November 9, 2016

Table of Responses to Public Comments on Draft NUREG-2195

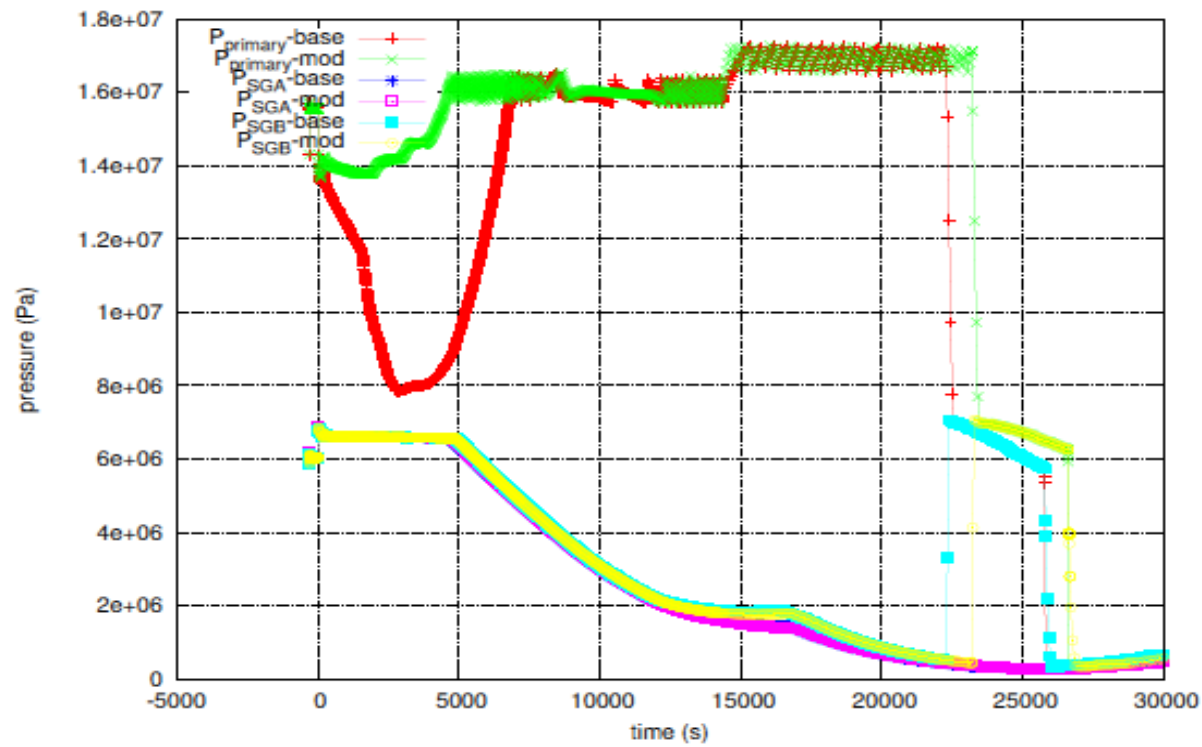
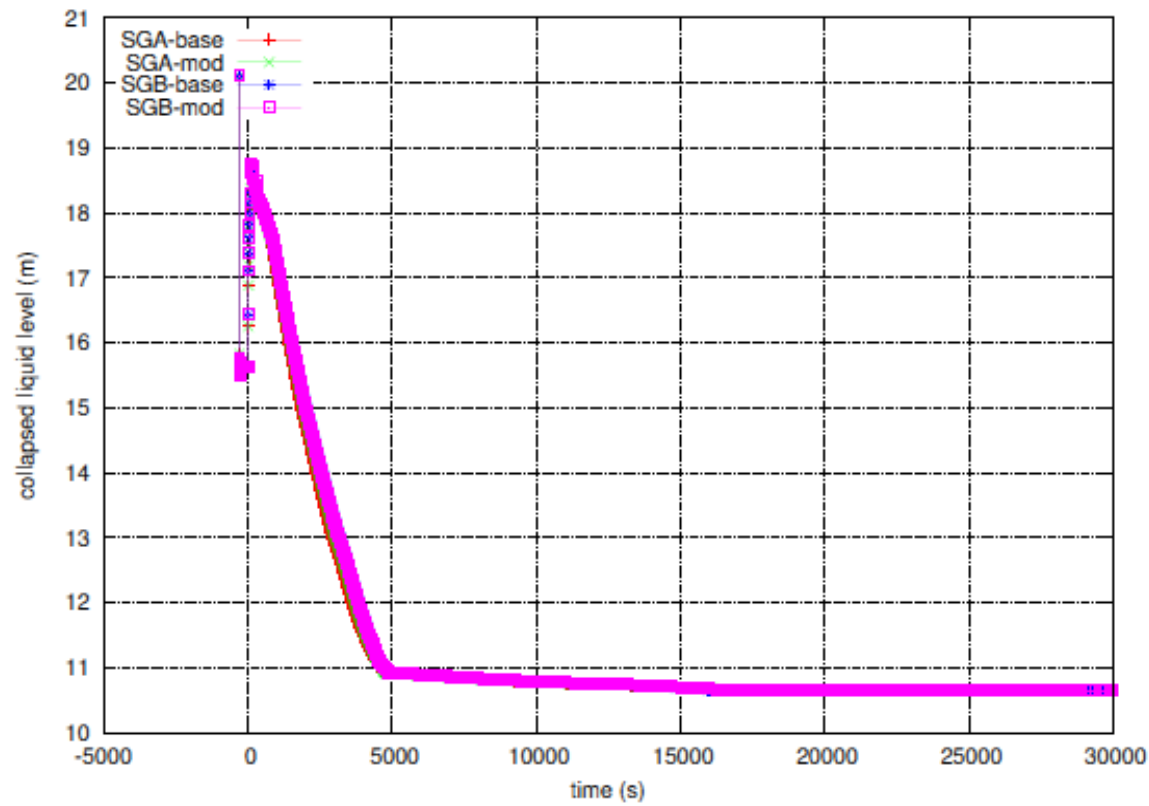
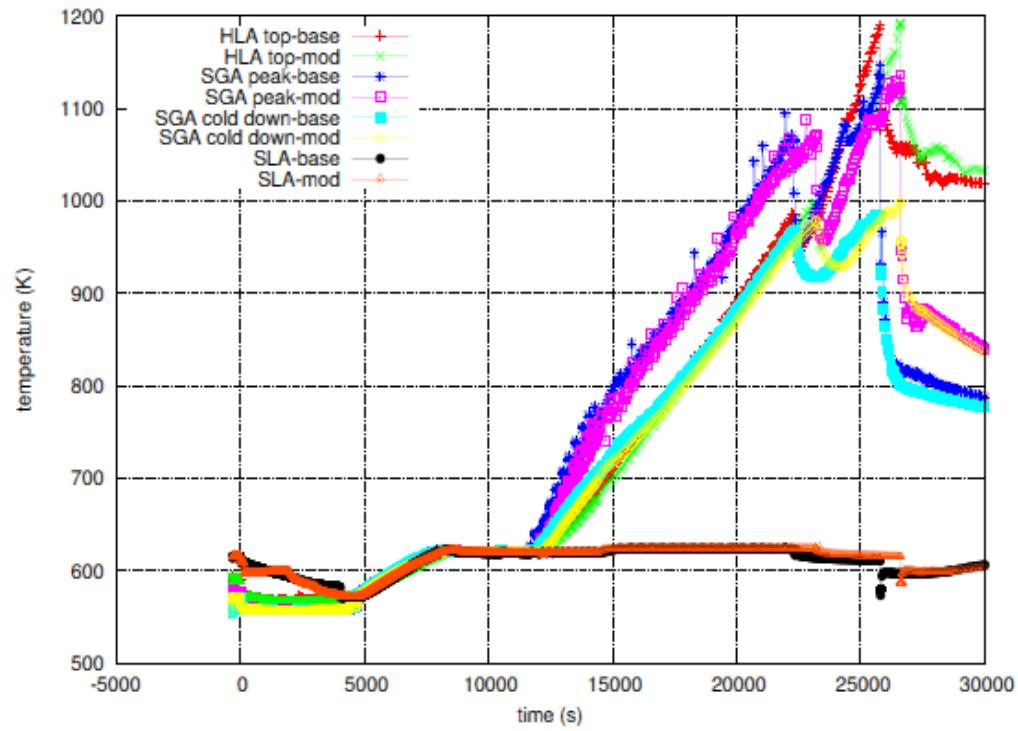
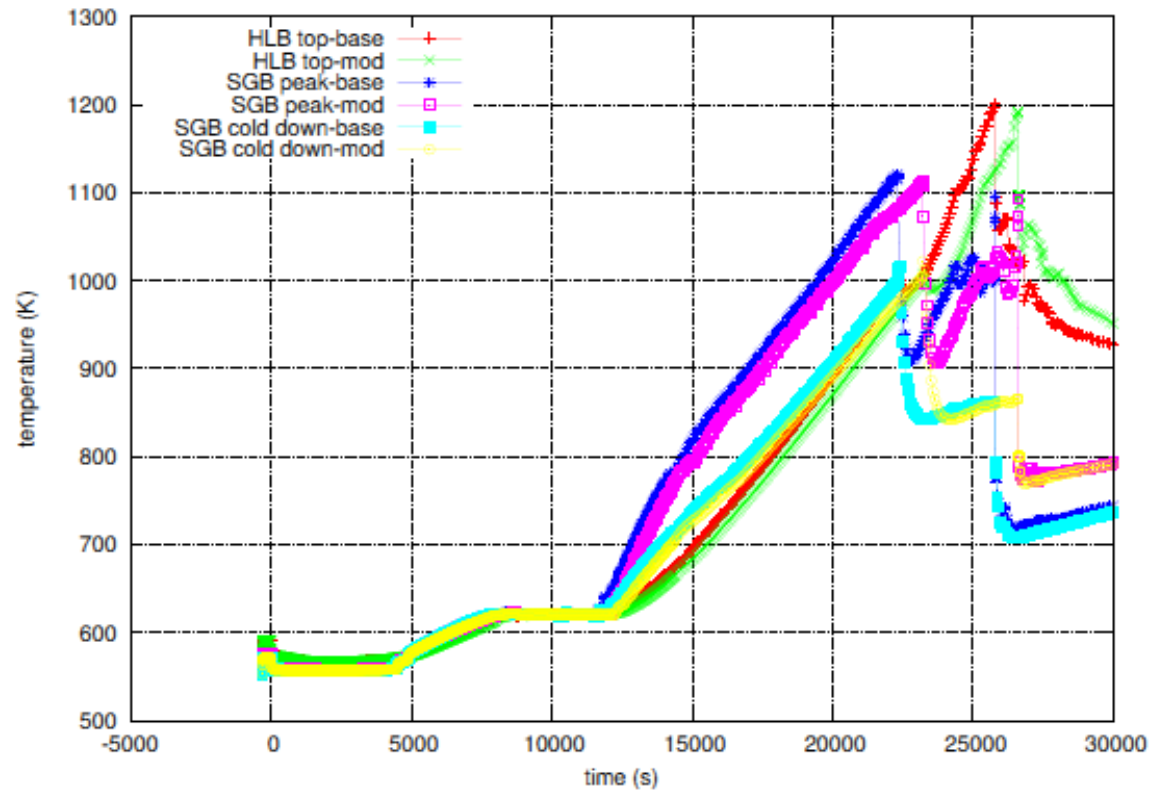
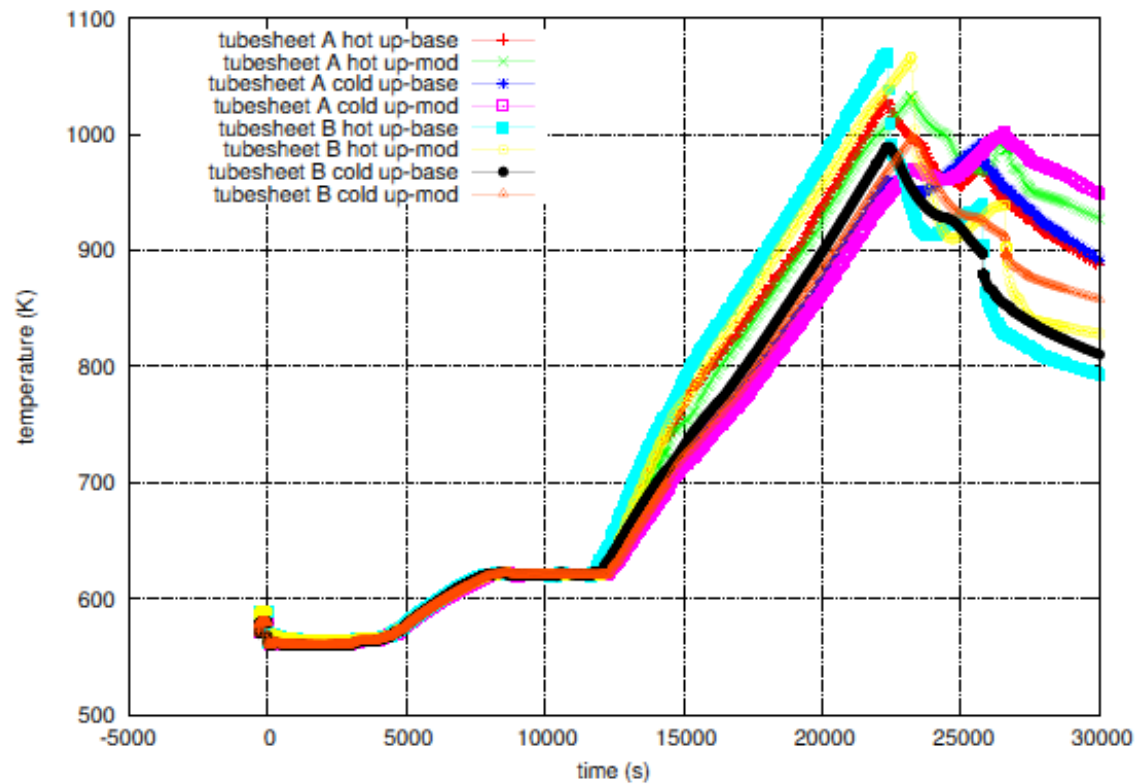
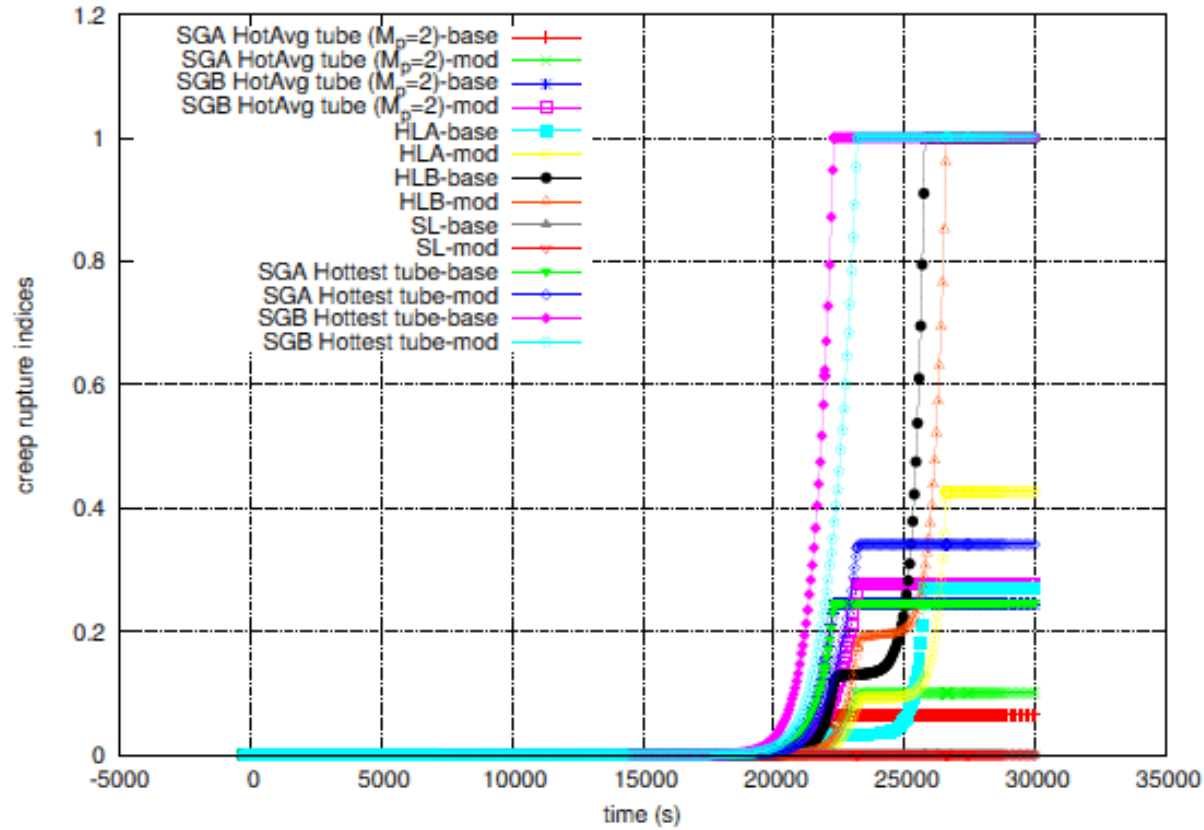
FYNAN Public Comment	RES Response	PUT IN NUREG?
	<p>primary side steam as it flows through the SG tubes are governed by this slow SG depressurization. The heating rate of the SG tubes may also be coupled to the SG secondary side depressurization. A primary side flow rate of 0(10) kg/s being cooled 100 deg C can raise the temperature of</p> <p>secondary side steam mass of <math>0(10^3)</math> kg by approximately 1 deg C/s. These are some of the subtleties that should be considered when comparing the base cases with other sequences with different secondary side depressurization assumptions.</p>		
5	<p>Comment 5 (Page 2-12, line 3):</p> <p>What is the technical basis for assuming 21 gpm per pump RCP seal leakage? Are these plant specific/installed pump seal package values or just assumptions? What is the effective leak path area modeled to obtain 21 gpm at operating RCS pressures? For all analyzed sequences in Chapters 3 and 7, it would be helpful to see a plot of the integrated mass flow through the pump seal leaks as a function of time compared to integrated mass flows through the pressurizer PORVs and SRVs. For the past 25 years, much time and effort has been spent in the severe accident simulation community agonizing over pump seal leakage modeling and many NUREG and topical reports have sections or chapters dedicated to the topic. However, it remains unclear whether the small mass and enthalpy flow rates through modeled nominal RCP seal leaks actually matter to any of the severe accident phenomena of interest in these studies.</p>	<p>The 21 gpm pump seal leakage is typical of a Westinghouse plant without SHIELD<sup>®2</sup>. CE plants with Flowserve or similar seals and Westinghouse plants with SHIELD<sup>®</sup> mechanical seals or Flowserve pumps or CE plants have very low leakages following SBOs (generally less than 2 gpm). The 21 gpm nominal seal leakage per RCP was assumed for the CE plant just for consistency with the Westinghouse plant.</p> <p>Additional MELCOR run was performed assuming no RCP leakage for the CE plant. The analysis indicated that even the small amount of seal leakage will impact the rate of early depressurization, the heat up rate will shift in time, but the conclusions regarding C-SGTR probability is not expected to be significantly changed.</p> <p>In response to another comment a simulation was rerun assuming no RCP seal leakage.</p>	Y

FYNAN Public Comment	RES Response	PUT IN NUREG?
		See response to question A.2.1. A plot of integrated mass flow through RCP seal leak for the stsbo case is provided in the attached document (Attachment A).	
6	<p>Comment 6 (Page 2-15, line 29-41):</p> <p>Is the discussion in this paragraph conjecture or has technical work or simulations been performed to support these statements? To clarify, this paragraph appears to be discussing the blow down of the high pressure RCS through SG tube breaks to the low pressure SG secondary side. The collapse of the countercurrent flow regime in the RCS primary side would be analogous to the temporary breakdown of the countercurrent flow when the pressurizer PORV or SRVs cycle. Is the conclusion of this paragraph that guillotine break of three tubes causes the blow down of the RCS that disrupts the countercurrent natural circulation flow? In lines 31-33, would such a blowdown event depressurize the RCS such that the accumulators inject possibly arresting core melt?</p>	<p>The discussion referred to by this comment was based on simplified analysis and it was originally intended for detailed Level 2 PRA evaluation. It is nor more pertinent to this study and it is therefore removed. The report was modified to reflect that.</p> <p>Regarding the primary depressurization as a result of the guillotine break of one tube, we do not expect that such a blow down event depressurize the RCS such that it results in accumulator injection. Section 7.1.6 of the report discusses that such a small leakage will not depressurize the primary such that accumulator/SIT injects unless additional tubes are failed.</p>	<p>Y</p> <p>1. Text was deleted. 2. Ref.4 was removed and other ref. numbers were changed, 3. Noted there are no references made in the text for Ref. 5 and 6. They were removed.</p>

Fig. 9: stsbo decay and oxidation power contribution

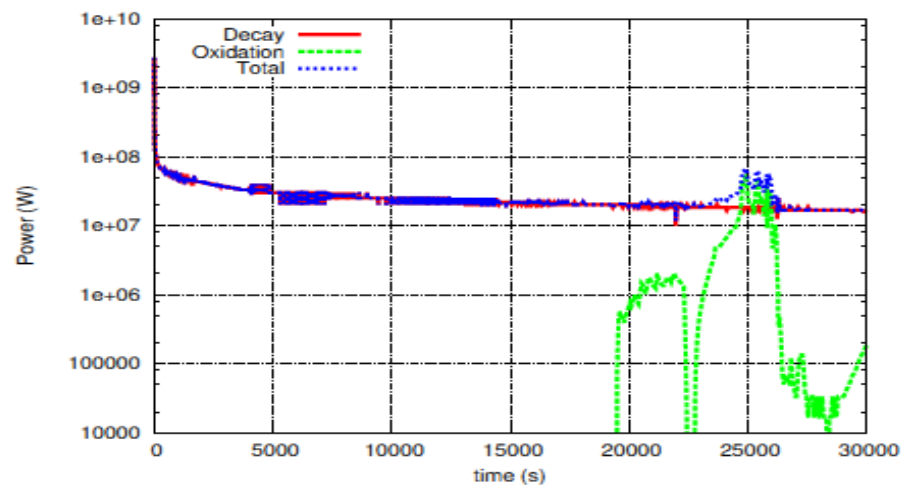
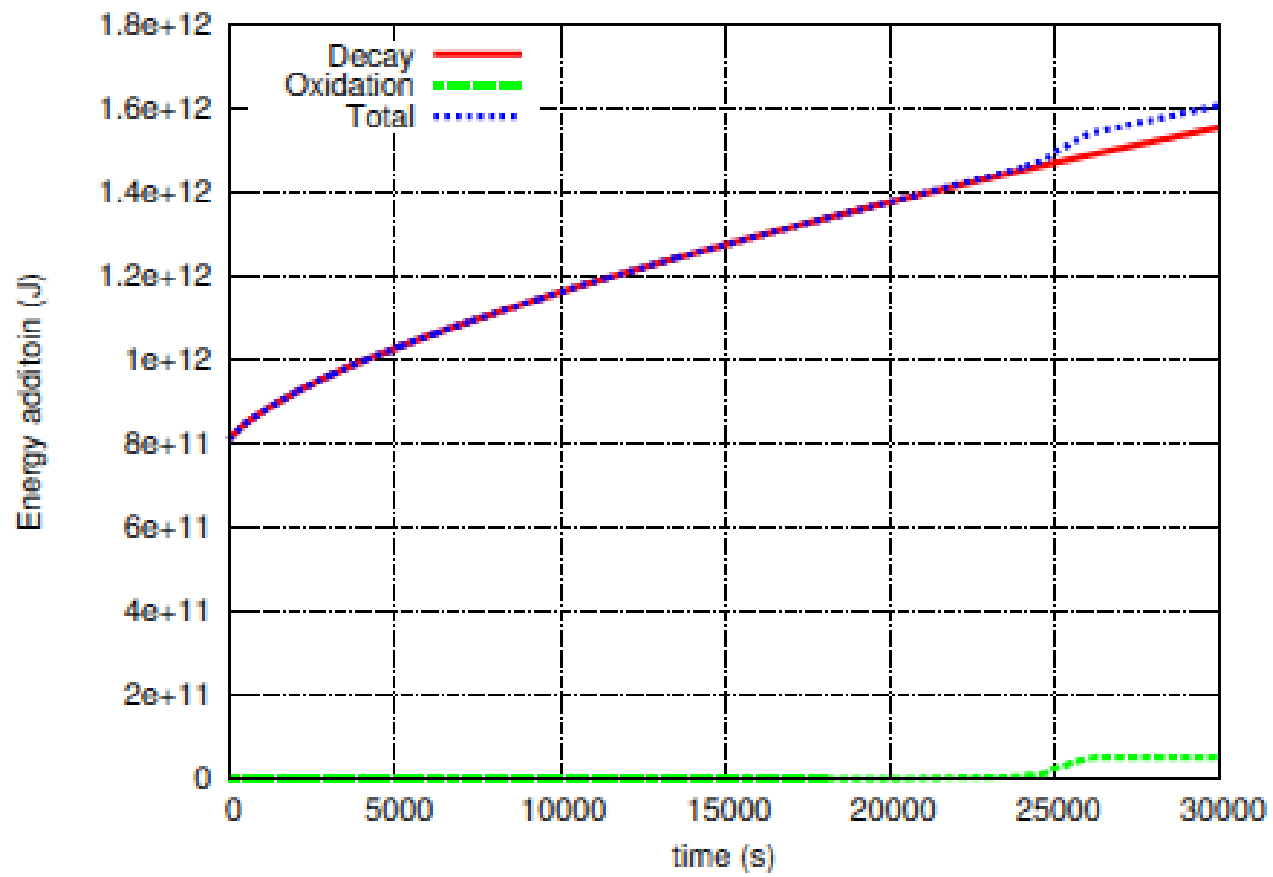
FYNAN Public Comment	RES Response	PUT IN NUREG?
	Quantify the statement "a little slower". This is a very significant result. Although the heatup of RCS components is occurring at very different absolute times (over 6 hours difference) the <i>heatup rates</i> are approximately the same.	<p>3-18. The stsbo and ltsbo sequences seem to be very similar – just time shifted.</p> <p>The average temperature rise for the hottest tube for stsbo-a was 0.58 K/s with a faster temperature rise of .078 K/s over approximately 2000 s and 0.052 K/s afterwards. For the ltsbo-a the average temperature rise for the hottest tube was 0.049 K/s. The faster rate was not as significant for the ltsbo case: ~0.55 K/s before and 0.48 K/s after the inflection. Note that these changed fluctuate somewhat with time and that the calculated rates depend somewhat on the bounds chosen for their evaluation.</p>	
20	Comment 20: (Page 3-42, line 40) See comment 17: show power from water metal reactions as function of time.	Plots of the decay and oxidation energies and powers and energies are provided in the attached document (Attachment A).

Fig. 11: Comparison of upper hot leg B velocities for different hot-leg natural circulation models

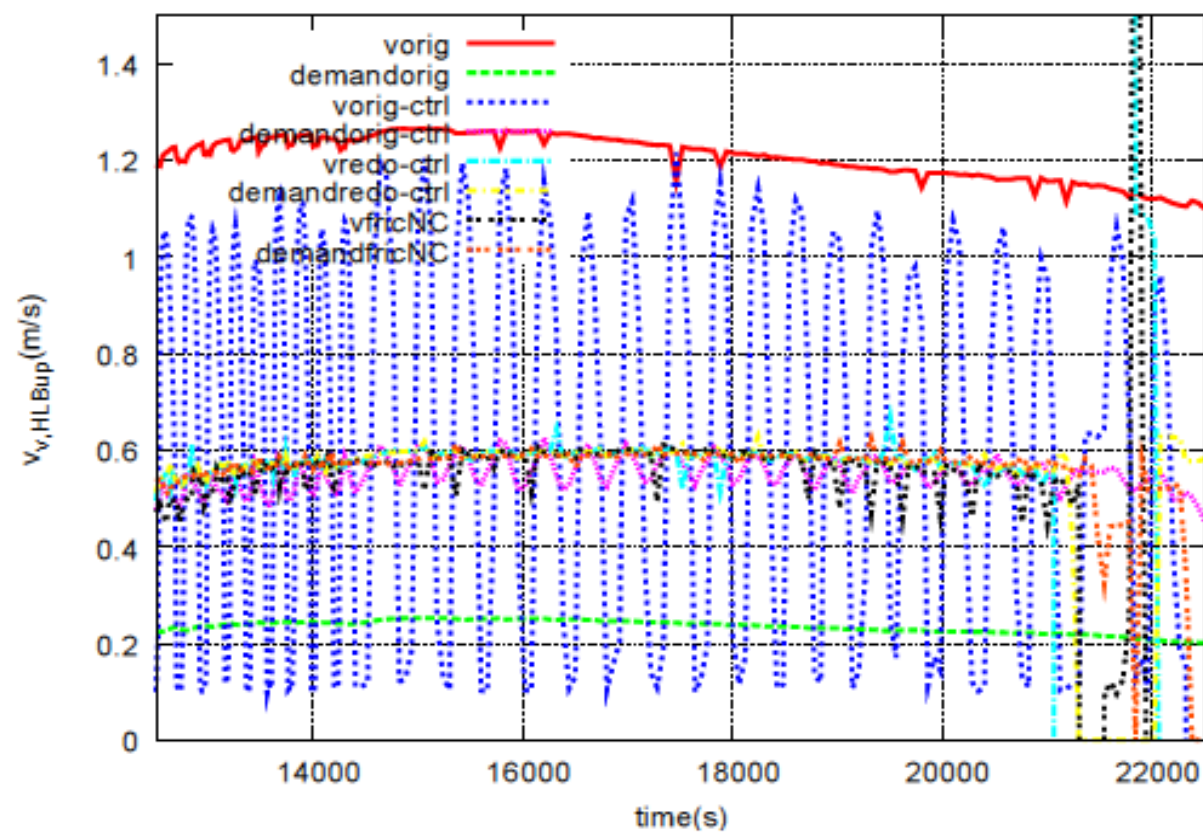
FYNAN Public Comment	RES Response	PUT IN NUREG?
		<p>one can approximate the pressure drop.</p> <p>The velocity for each segment was approximately ½ m/s for a differential velocity, and differential velocity squared, of about 1.</p> <p>The density varied with increasing temperature but was in the range of 50 kg/m<sup>3</sup>.</p> <p>So the differential pressures resulting from the countercurrent flows were approximately in the range of:</p> $dP \sim 1.875 \times 50 \text{ [kg m}^{-3}\text{]} \times (1) \text{ [m}^2 \text{ s}^{-2}\text{]} \sim 94 \text{ Pa}$	
14	<p>Comment 14 (Page 3-19, lines 34-35):</p> <p>Please quantify the statement "...were found to be higher than those of Fluent". Why do higher (and quantify how much higher) hot-leg velocities prefer tube over HL failure? Do heat transfer coefficients and residence time change as a function of velocity? See comment 1: the result of different heat transfer coefficients and residence time can be observed in the heatup rates.</p>	<p>It was a significant fraction- some tens of percent. The specific amount was never quantified because it represented an intermediate stage in the deck development process.</p> <p>Note that this relates to the modeling described in your questions 12 and 13.</p> <p>As mentioned in those responses user-added models set the HL velocities. The fact that the velocity was off just indicates that the user-added model wasn't calibrated and does not reflect something inherent to the MELCOR code.</p> <p>No specific higher velocity threshold that prefers tube failure over HL is expected. The expectation that higher</p>	N

FYNAN Public Comment	RES Response	PUT IN NUREG?
		<p>velocities favor SG failure results from the following general reasoning: the temperature drop over the HL is less at higher velocities resulting in a slightly higher temperature of gas entering the tubes. Since not much cooling occurs this effect is not expected to be large.</p> <p>Both heat transfer coefficients and residence time do indeed depend on velocity.</p>	
15	<p>Comment 15 (Page 3-20, line 32):</p> <p>This behavior <i>is</i> scenario dependent. Most of the cases presented later in Ch. 3 assume the 0.5 in<sup>2</sup> secondary leakage which also controls secondary depressurization after TI-SGTR and RCS blowdown to the secondary side. See Figure 3-5 on page 3-26 from 23000 seconds to 26000 seconds. If the initial depressurization is modeled as an opened ADV, the release to the environment will be much greater.</p>	<p>Yes, fission product releases would differ for open relief valve scenarios.</p> <p>The statement in the document referred to whether or not releases would occur in different closed-secondary-relief-valve scenarios.</p>	N
